# ADDENDUM

Project: LDS Maywood Chapel HVAC Replacement

Addendum No.: 1

From (Architect): Engineered Systems Associates

M-1

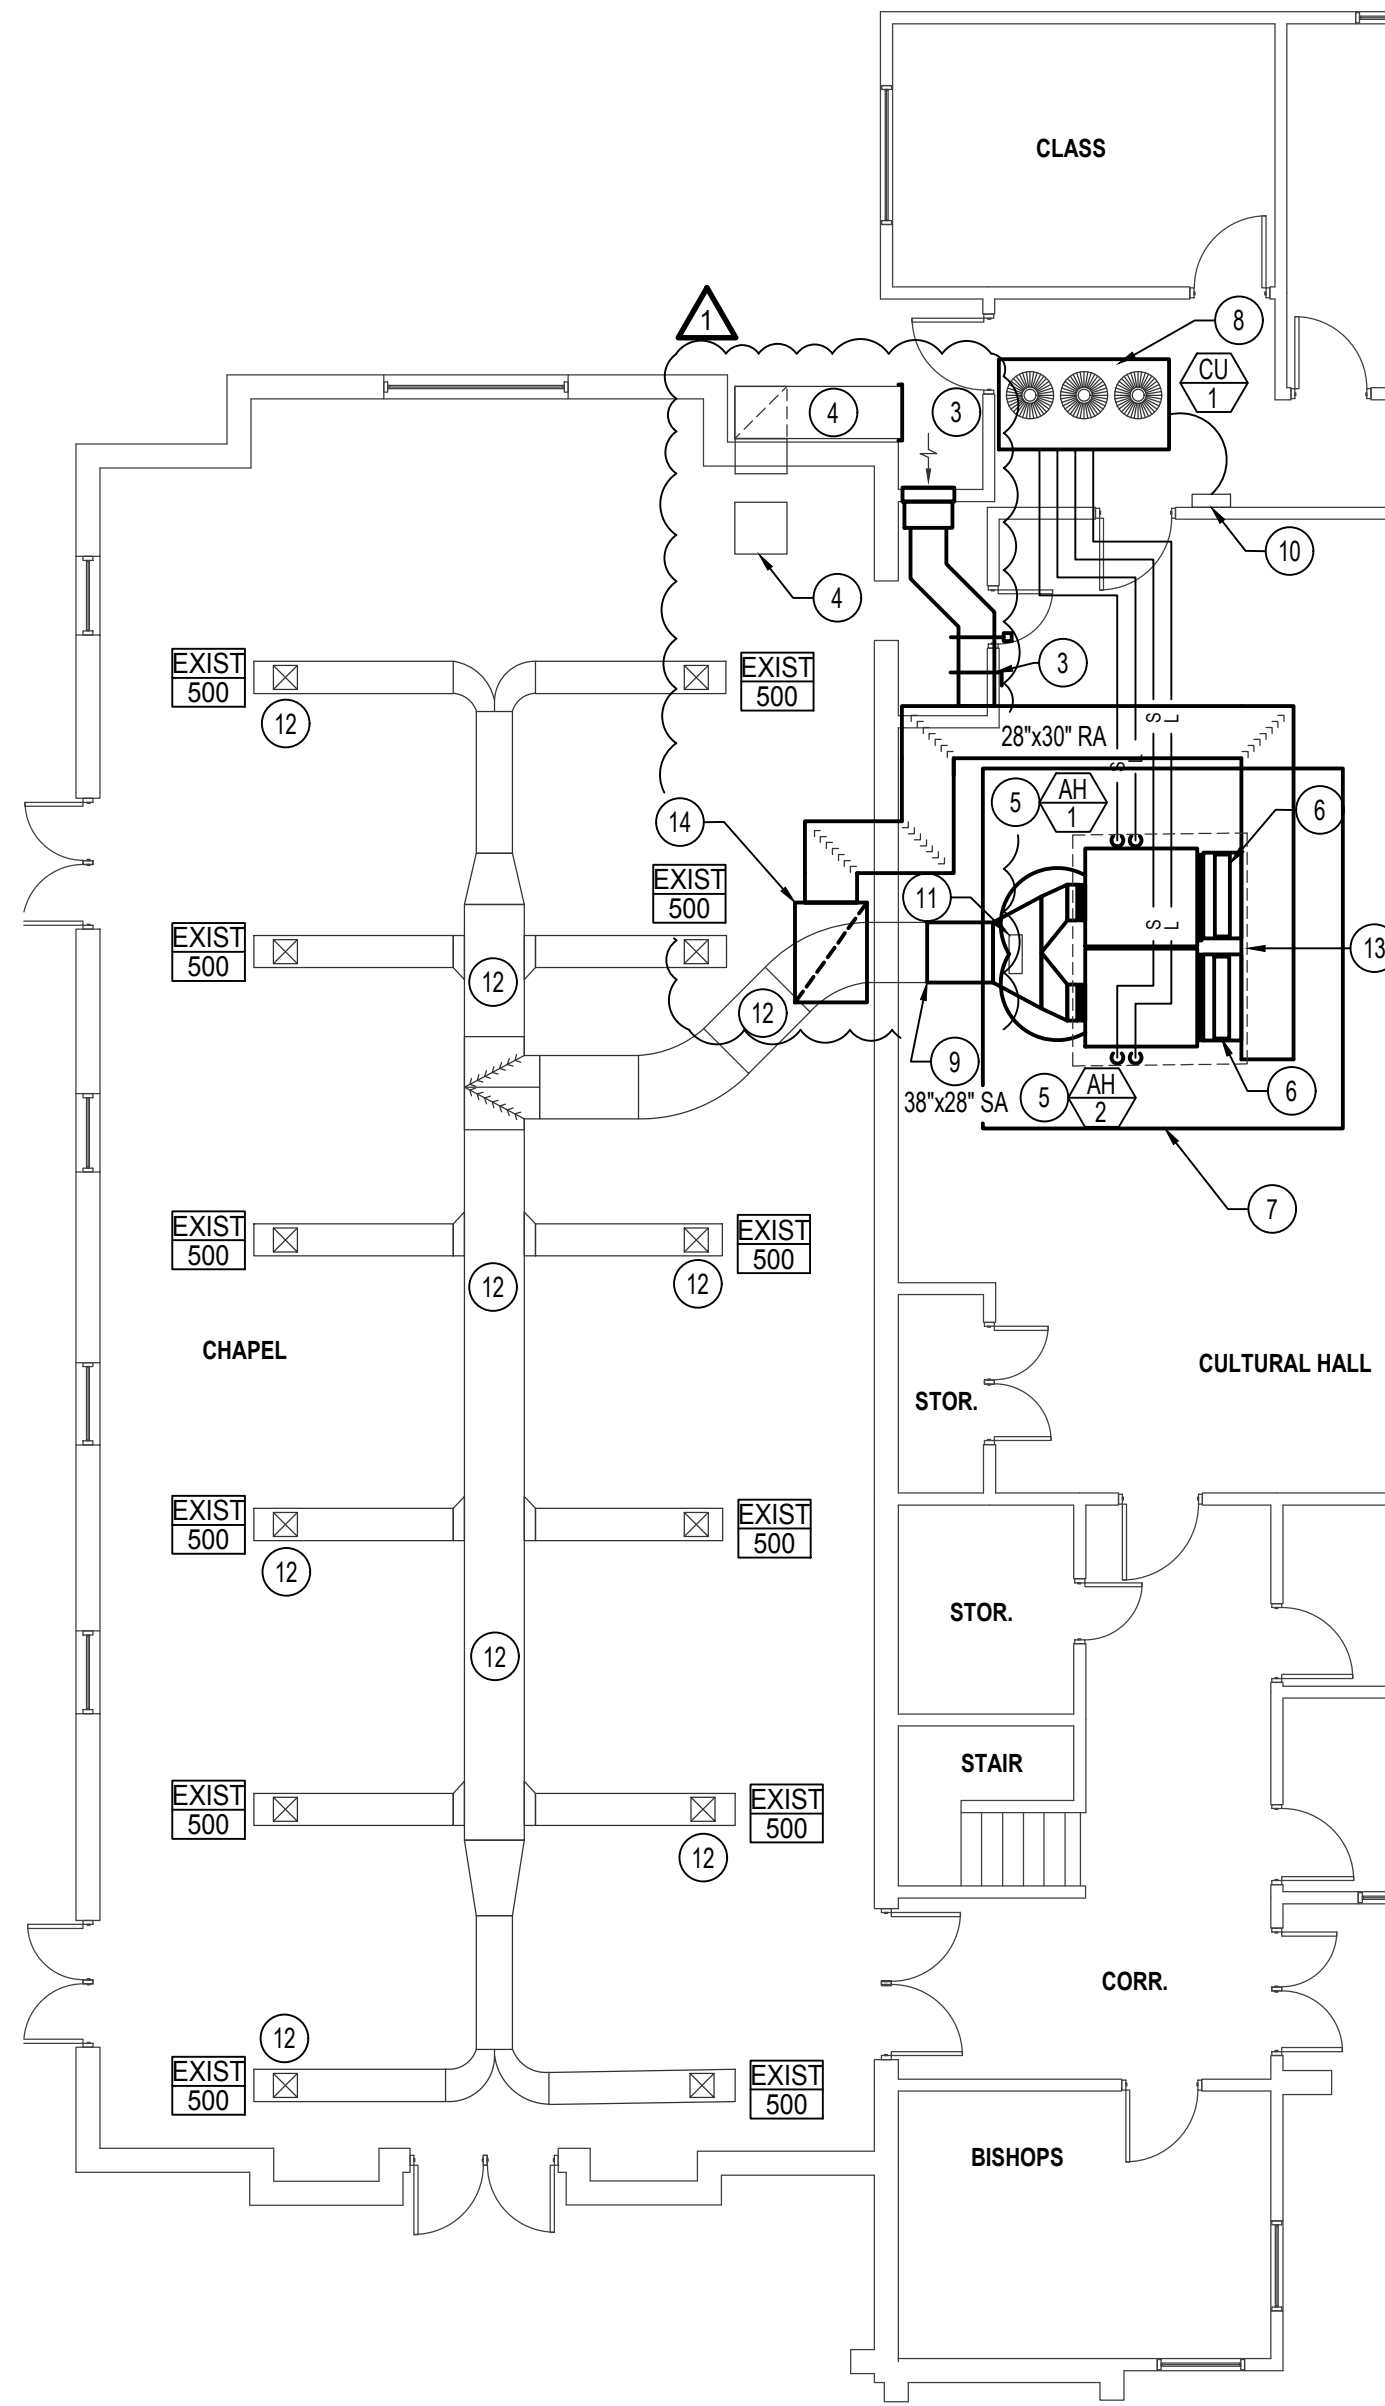
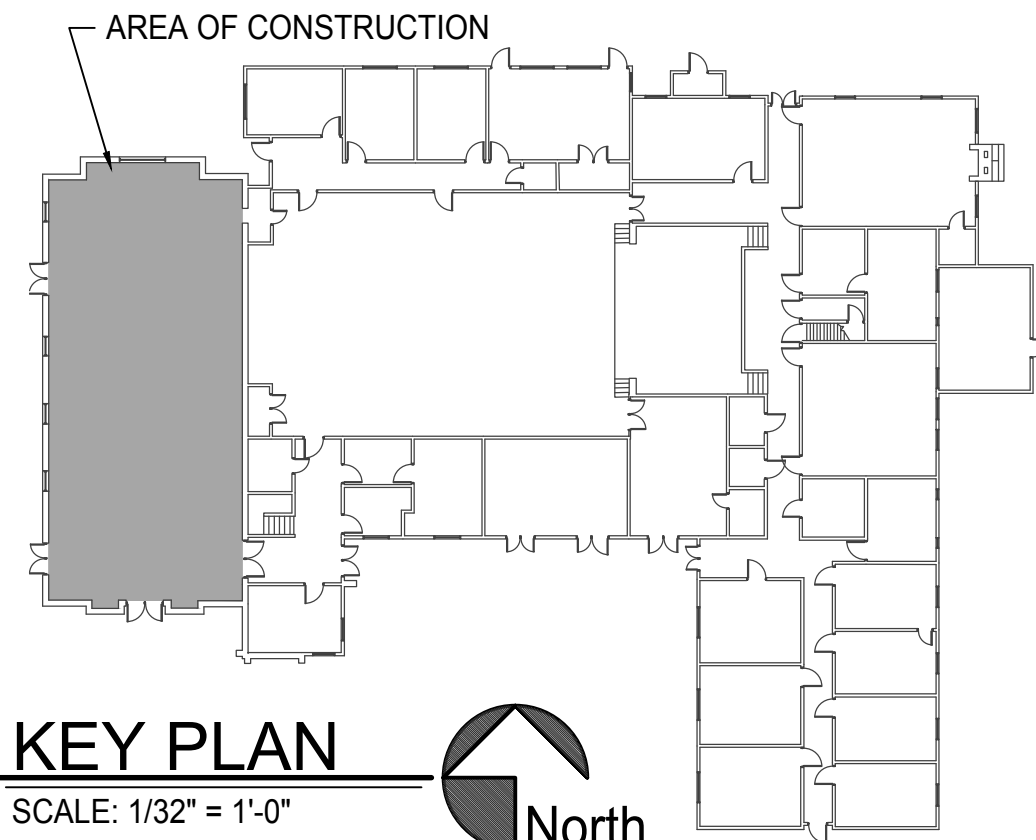
a. Sheet M-1: The return and outside air ductwork has been revised to use the existing sound grille on the ceiling. The outside air louver will be located at the wall penetration of the existing duct. The existing return air fan and duct to crawl space will be abandoned in place and the duct will be capped.

- 3 PROVIDE 28"x28" OUTSIDE AIR LOUVER IN EXISTING WALL OPENING. PROVIDE SLEEVE AND 28"x28"x12" PLENUM. OUTSIDE AIR DUCT SHALL HAVE HAND AND MOTORIZED DAMPERS. MOTORIZED DAMPER TO OPEN IN OCCUPIED MODE WITH 24V TRANSFORMER FROM THERMOSTAT. BALANCE HAND DAMPER TO 1450 CFM OUTSIDE AIR. CAP EXISTING DUCT TO BASEMENT. REPAIR TO MATCH EXISTING.

- 14 EXISTING 36"W x 50"L CEILING GRILLE FOR OLD SPEAKER TO REMAIN AND BE USED FOR RETURN AIR GRILLE. PROVIDE A LINED 36"W x 50"L x 30" H RETURN AIR PLENUM ABOVE THE EXISTING GRILLE AND SEAL TIGHT. CONNECT NEW 28"x30" RETURN AIR DUCT. CLEAN EXISTING GRILLE PRIOR TO INSTALLING NEW WORK.
